From: [Osborne-Shaw, Beverley](#)
To: [BramfordtoTwinstead](#)
Cc: [REDACTED] [@babergh.gov.uk](#)
Subject: FW: Planning Inspectorate your Ref : EN020002
Date: 11 October 2023 16:25:01
Attachments: [Dedham Vale East Cable Sealing End Compound.pdf](#)

Dedham Vale East Cable Sealing End Compound

This written representation is to disagree with the location of the proposed **Dedham Vale East Cable Sealing End Compound** on Millwood Road and to propose an alternative site.

ALTERNATIVE SITE SUGGESTION FOR THE DEDHAM VALE EAST CABLE SEALING END COMPOUND

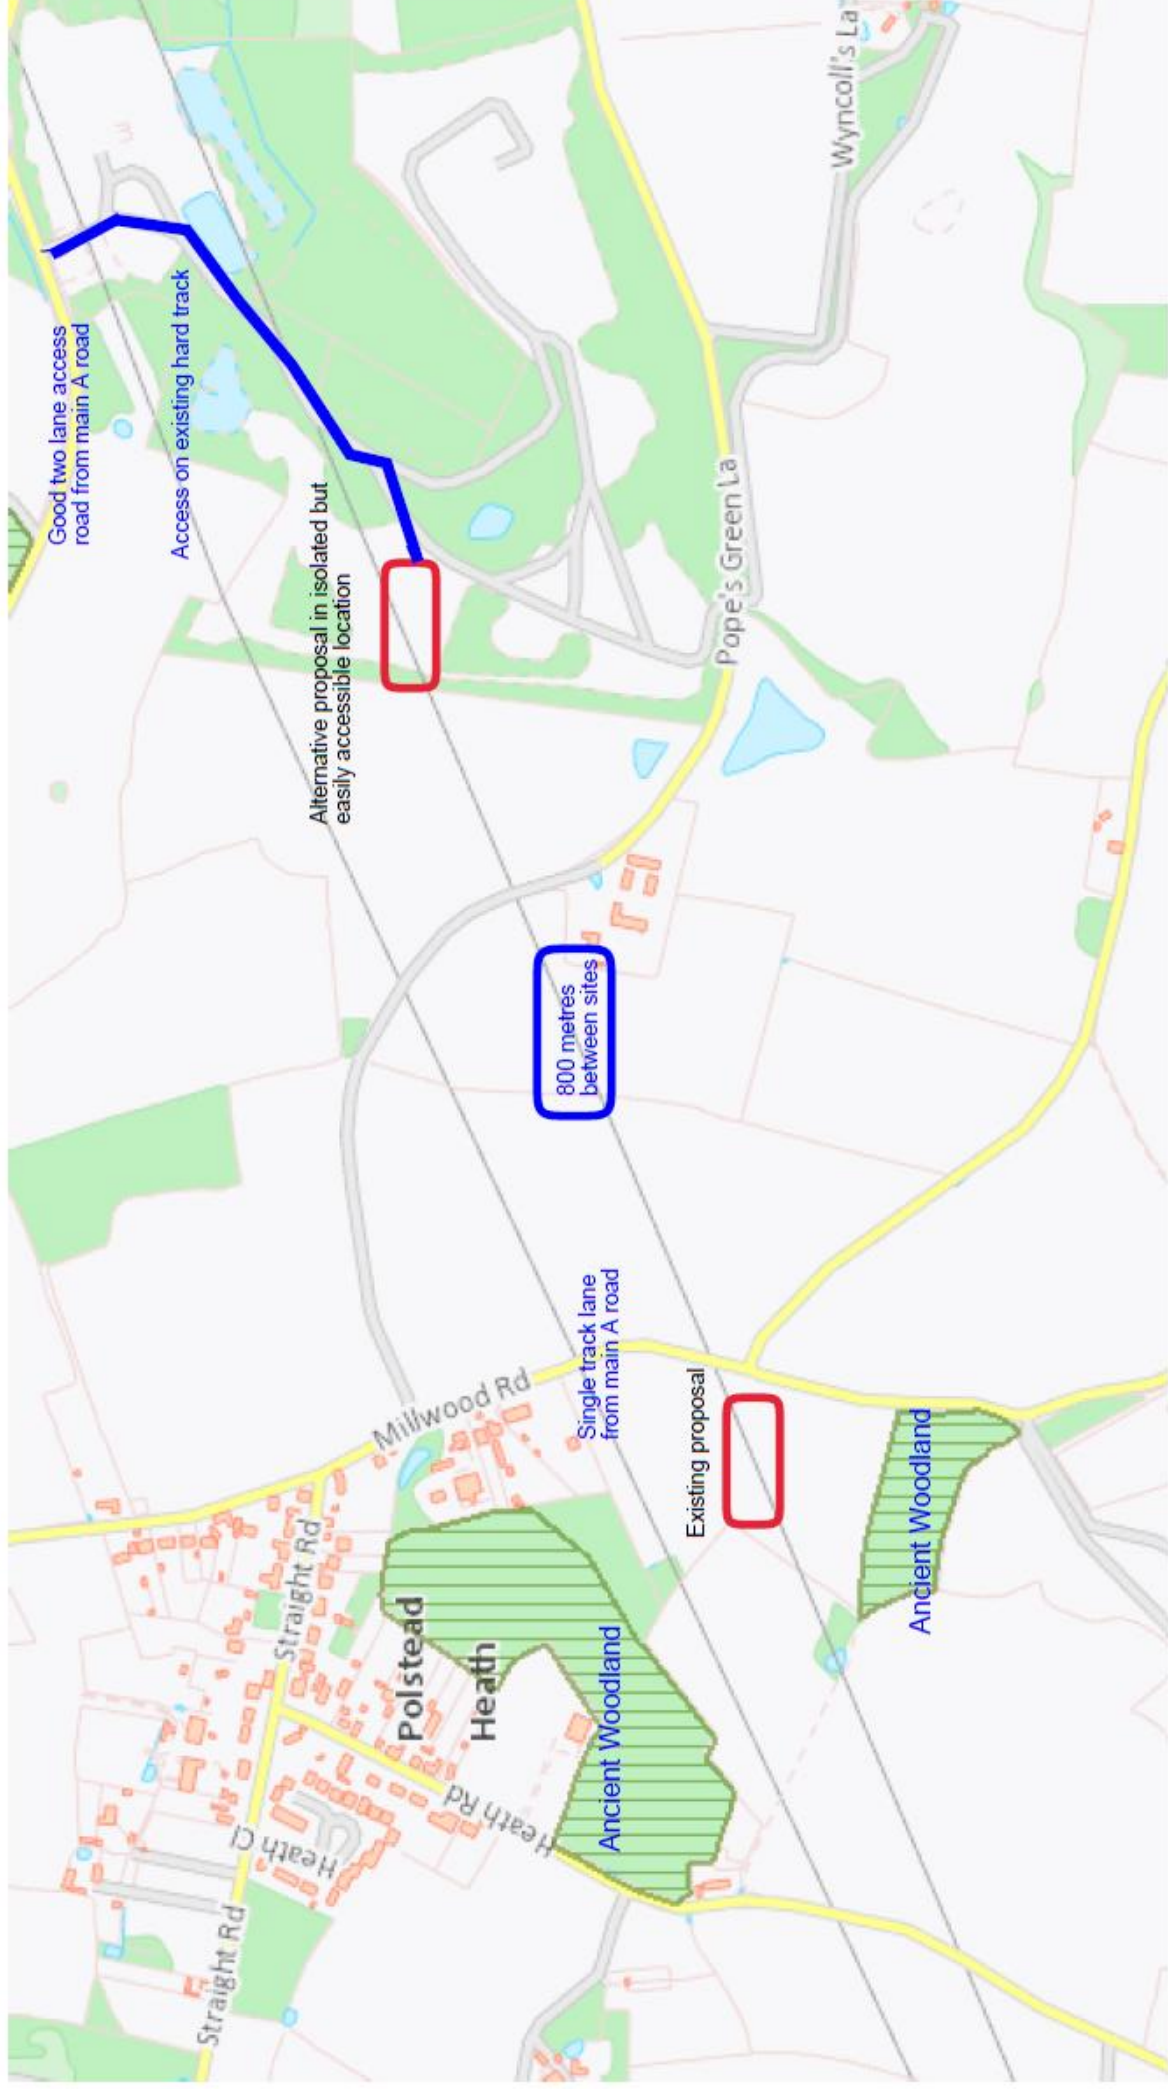
In order to show why there is a much better location the list of **'Initial Assessment of Principle Issues'** has been used to compare both sites. The plan shows both sites with key features identified.

The alternative proposed site in the nearby disused gravel pit has significant advantages over the Millwood Road site in every category of the **'Initial Assessment of Principle Issues'**. The land in between the two sites is level and in a straight line so in terms of trench construction, this is a straight forward minor addition in length to the underground trenching with no technically difficult engineering problems.
